**PLANNED UNIT DEVELOPMENT  
& SUBDIVISION STAFF REPORT****Date: June 5, 2008**

**DEVELOPMENT NAME** Dobbs Industrial Park Subdivision, First Addition,  
Resubdivision of Lots 1 & 2

**LOCATION** 3730 Halls Mill Road  
(North side of Halls Mill Road, 130'± West of Varner  
Drive)

**CONTEMPLATED USE** Planned Unit Development Approval to allow two  
buildings on a single building site.

# SITE PLAN

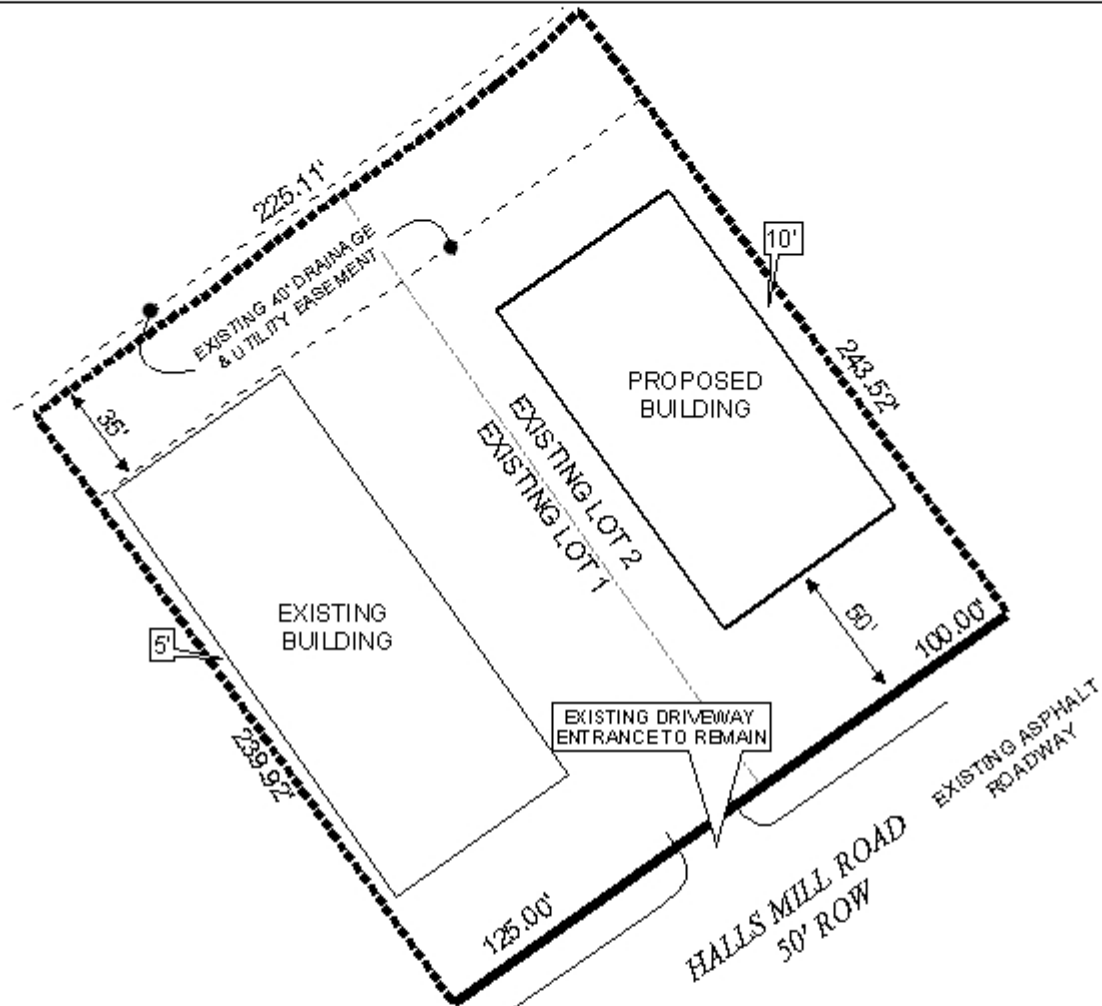
The lot is not labeled with its size; therefore, the plat should be revised to label the lot with its size in square feet and acres, or a table should be furnished on the final plat providing the same information.

Regarding the PUD, the site plan submitted indicates an existing sheet metal and guttering fabrication building and a proposed second building for the site. No narrative was submitted giving a detailed description of use for the proposed building or time table for expansion. The site plan submitted indicates all property line setbacks to be compliant, and site coverage is determined to be compliant graphically, however, no site coverage calculations are given. No internal circulation or parking is indicated, and no indication of truck loading/unloading, if any, is indicated. Only the existing curb cut to Halls Mill Road is shown to remain. There are no parking calculations provided based on internal square footage uses of the buildings, warehouse employees, etc., and no landscaping areas and tree plantings are shown or calculations provided. No storm water detention area is indicated, but no verification is furnished that such would not be required. No dumpster is depicted on the site plan. If a dumpster is proposed, it should be depicted on the site plan, or a statement should be provided indicating that no dumpster will be included as part of the development. The site plan is based on the current recorded lots with a 50' right-of-way for Halls Mill Road and does not take into consideration any impact of the required dedication. All site improvements would have to be situated out of any required frontage dedication.

**Planned Unit Development:** Based on the preceding, this application is recommended for holdover to the meeting of May 1<sup>st</sup> to allow the applicant to revise the site plan to include the following:

- 1) inclusion of a narrative giving a detailed description of the use of the proposed building and a timetable for expansion;
- 2) inclusion of calculations for site coverage, parking ratios based on internal uses of buildings, and for landscaping and trees;
- 3) depiction of parking, internal circulation, dumpster location (if any), truck loading/unloading (if any), and storm water detention (if any); and
- 4) revision of the site plan to indicate all improvements based on required frontage dedication.

- 1) no narrative was furnished giving a detailed use of the proposed building and a timetable for expansion;
- 2) no calculations were furnished for site coverage, parking ratios based on internal uses of buildings, or for landscaping and trees;
- 3) the site plan was not revised to depict parking, internal circulation, dumpster location (if any), truck loading/unloading (if any), and storm water detention (if any); and
- 4) the site plan was not revised to indicate all improvements based on required frontage dedication.

- 1) no narrative was furnished giving a detailed use of the proposed building and a timetable for expansion;
- 2) no calculations were furnished for site coverage, parking ratios based on internal uses of buildings, or for landscaping and trees;
- 3) the site plan was not revised to depict parking, internal circulation, dumpster location (if any), truck loading/unloading (if any), and storm water detention (if any); and
- 4) the site plan was not revised to indicate all improvements based on required frontage dedication.

- 1) dedication of right-of-way to provide 35' from the centerline of Halls Mill Road;
- 2) illustration of the 25' minimum building setback line as measured from the dedicated right-of-way;

- 3) placement of a note on the final plat stating that the site is limited to the existing curb cut to Halls Mill Road, with its size, location and design to be approved by Traffic Engineering and conform to AASHTO standards;

- 4) revision of the plat to label the lot with its size in square feet and acres, or the furnishing of a table on the plat providing the same information;
